MEETING MINUTES

**RE:** **Floyd College Bartow Center**  
**CC Project No. 200120/D.1**  
**Meeting January 10, 2002**

Floyd College  
Bartow Center

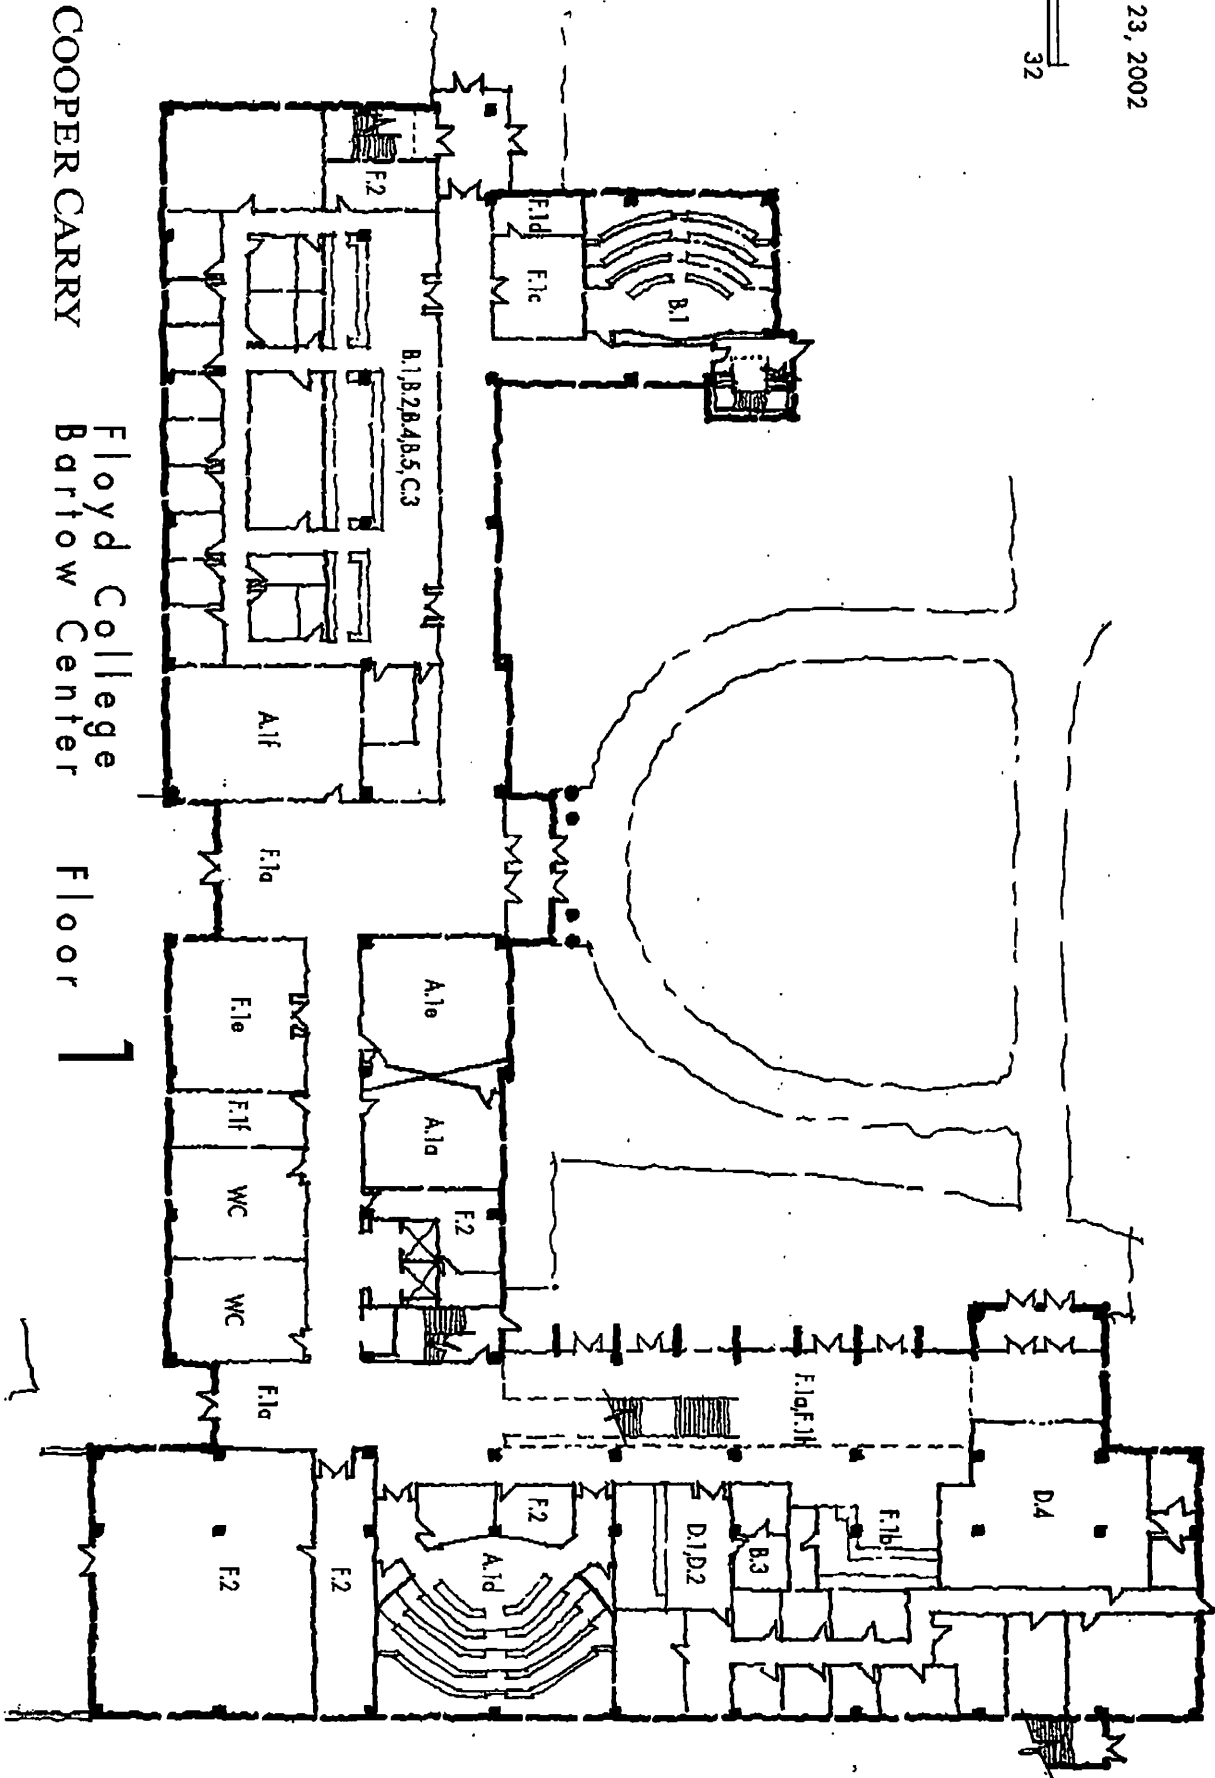
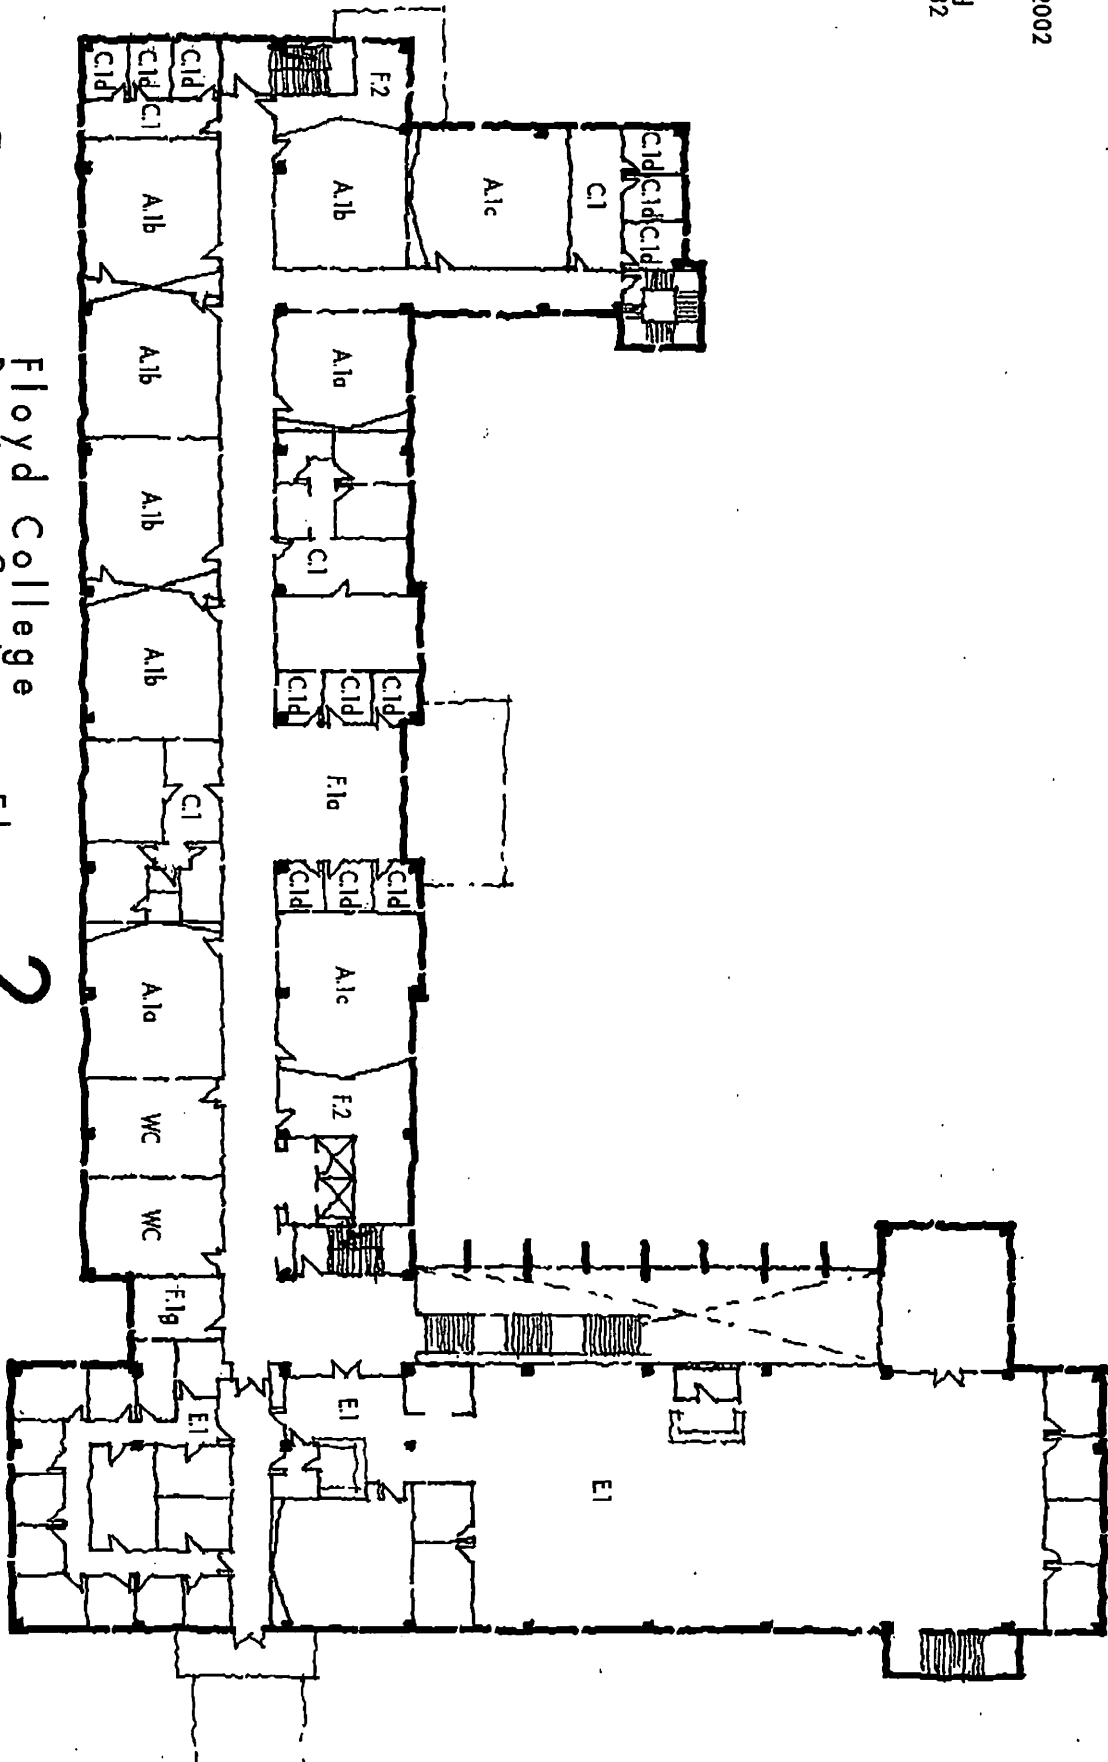
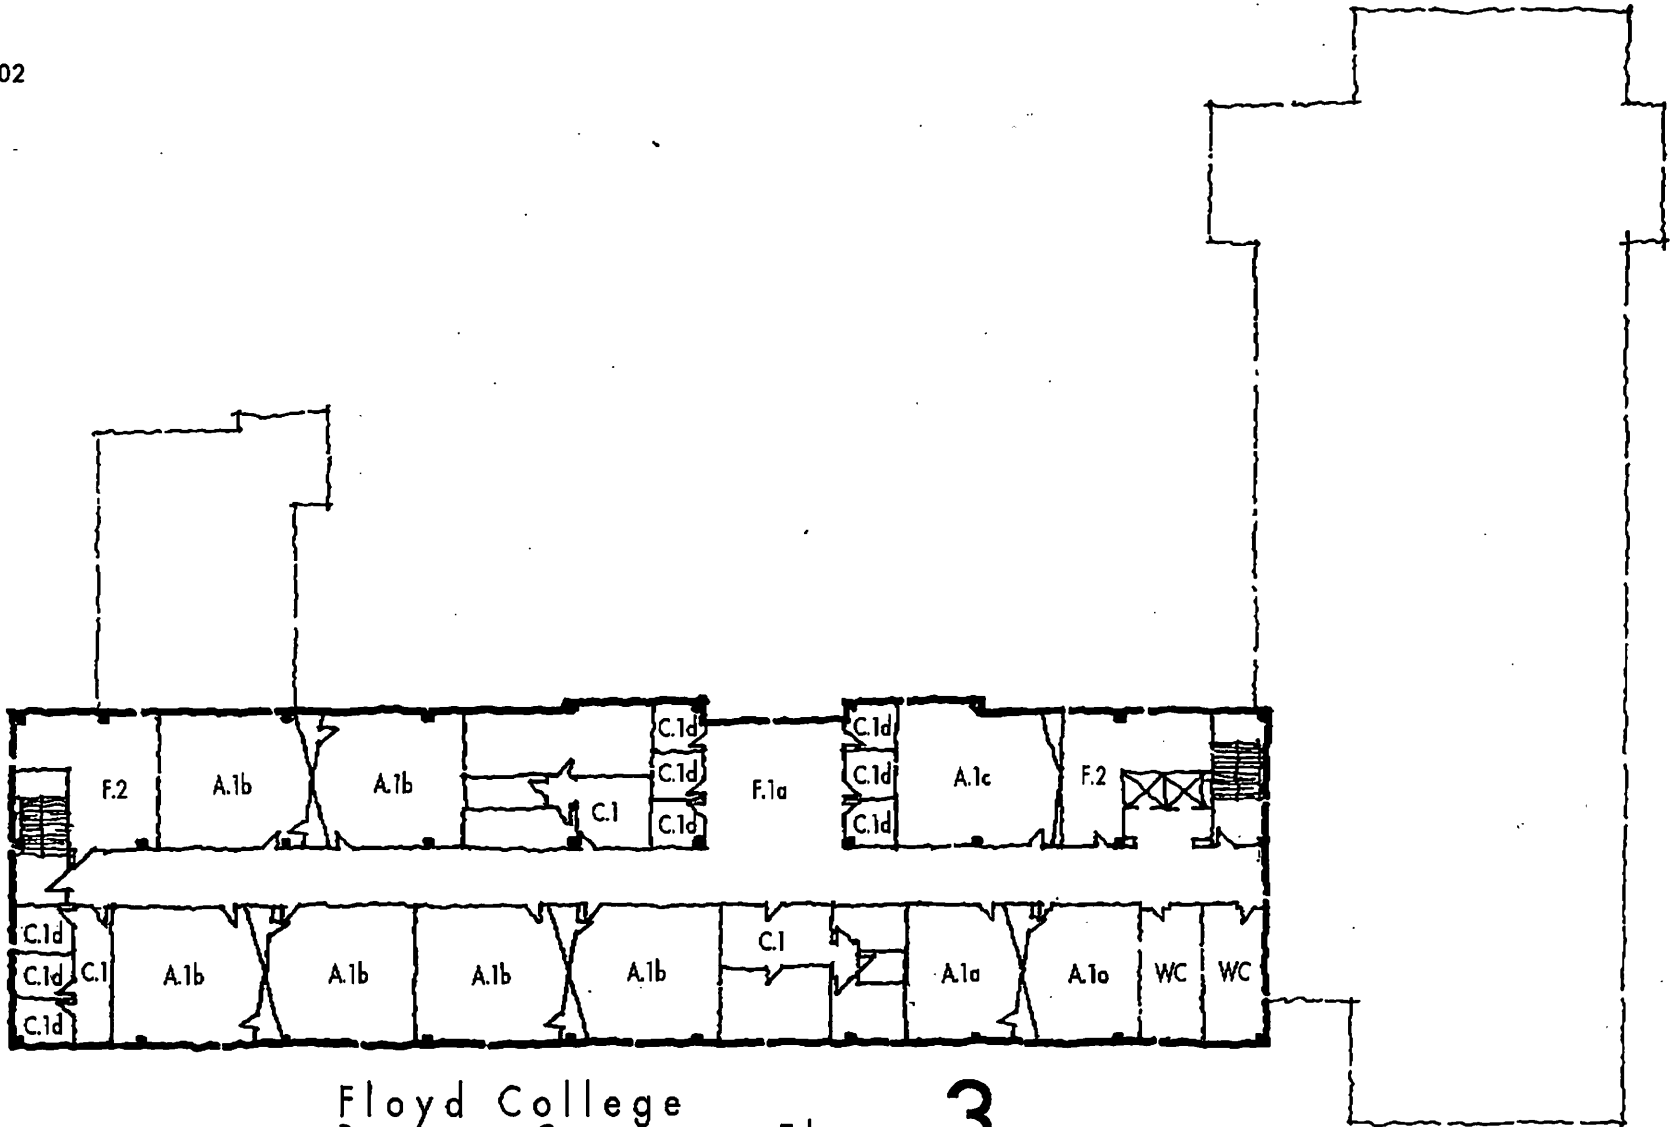
Schematic Plan Development for review  
+ comment. Gross area as shown is 98,000 sq. ft.  
... which is in budget range. Stack area in  
library is a bit under program @ 5,000 sq. ft.  
i.l.o. 7,700 sq. ft. The plan currently shows one  
more mid-size classroom than the revised program.  
Please call to discuss at your earliest convenience.
